**CONTINUING ELIGIBILITY INSPECTION (CEI) REPORT FOR
FLOOD CONTROL WORKS (FEDERAL)**

Honolulu Engineer District
CEPOH-EC-T

1. Project Name: Asan River Flood Control Project
2. Date of Inspection: March 24, 2004
3. Inspection Personnel:

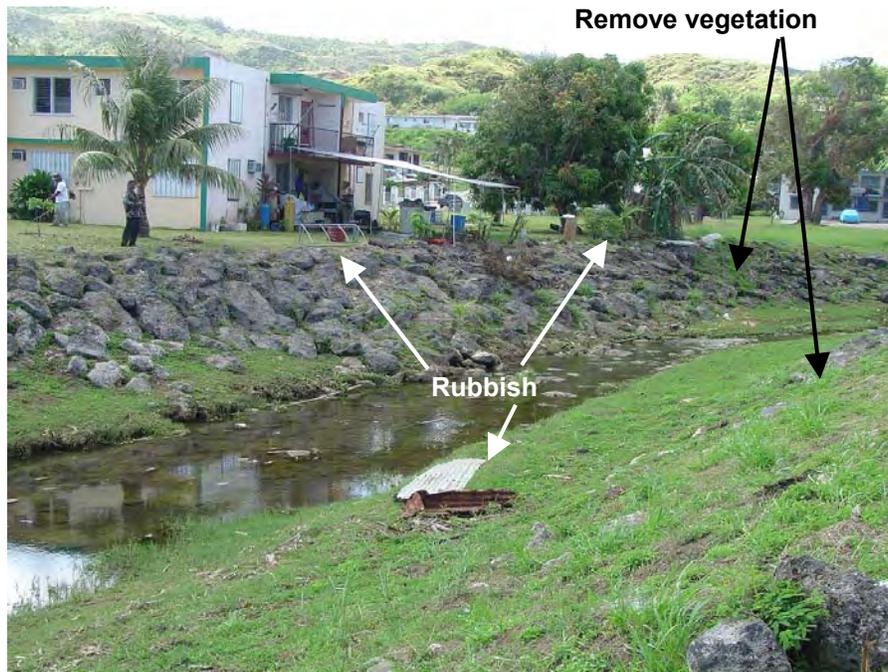
c. Sta. 8+00 (approx), Remove vegetation from riprap slope protection, right bank looking downstream toward Marine Drive

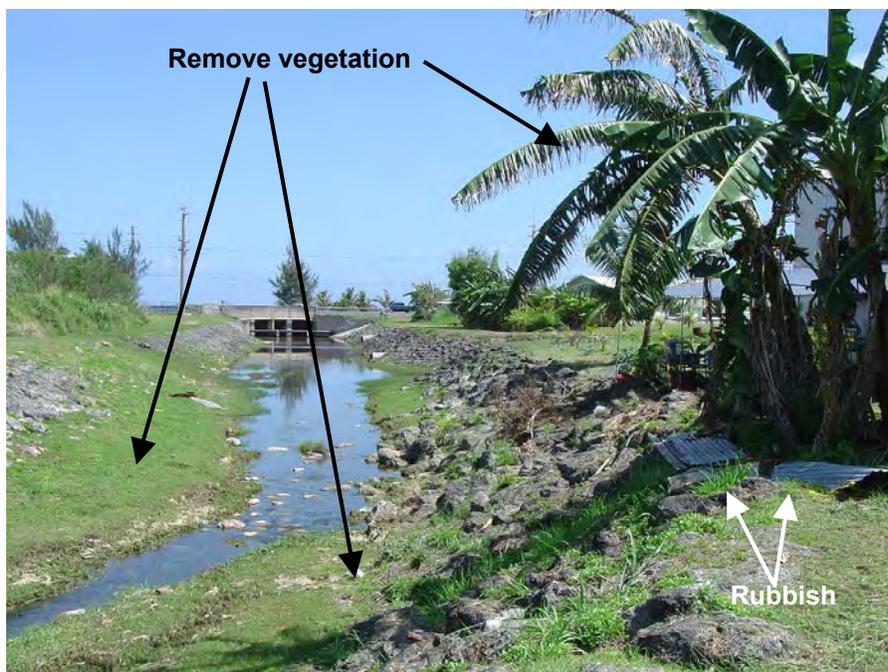
d. Sta. 8+50, Project looks good in this reach, nice vegetation removal, can see riprap, continue herbicide control on banks, looking upstream from Marine Drive

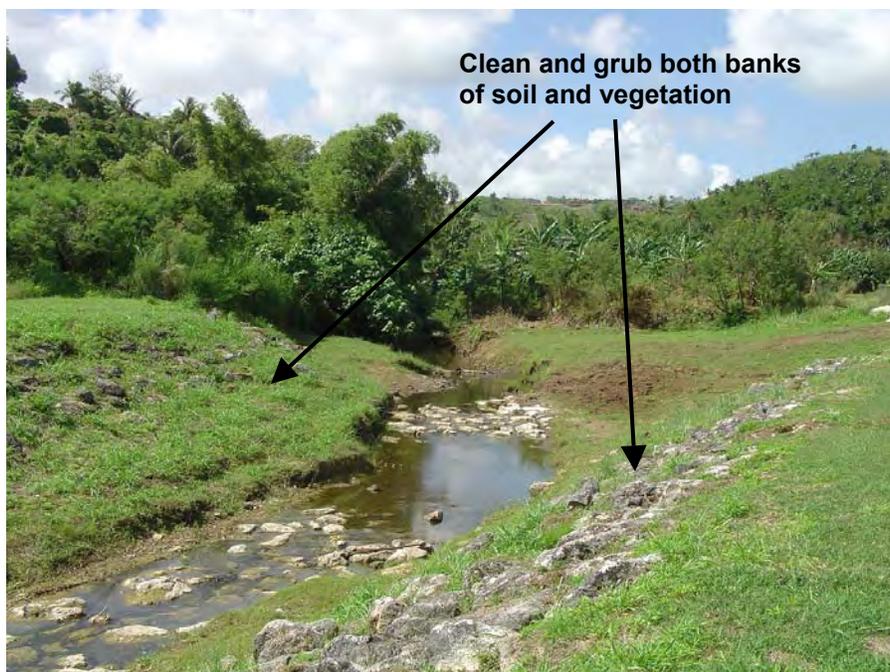
f. Sta. 13+50, RB remove rubbish and remove trees and vegetation in the maintenance ROW, looking downstream

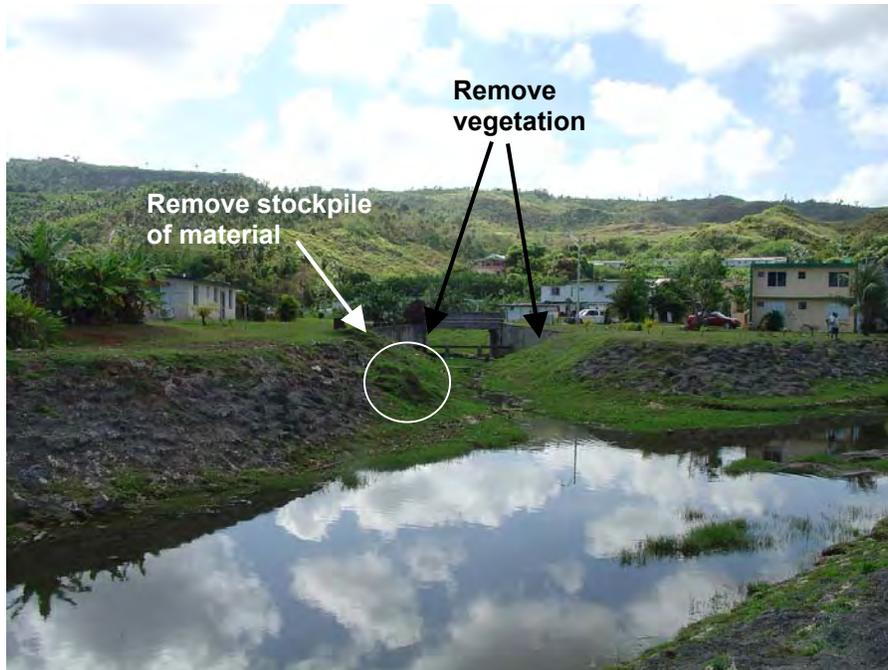
- i. Sta. 14+75 (approx), Unplanned and unauthorized drainage channel entering Project, need to contact owner or Village to get a correct design for this ditch. Outlet (top picture) should be oriented at an angle downstream in the direction of flow, located on the LB of Project. Multiple piping is good idea, but small pipes may clog causing backup of ditch drainage.
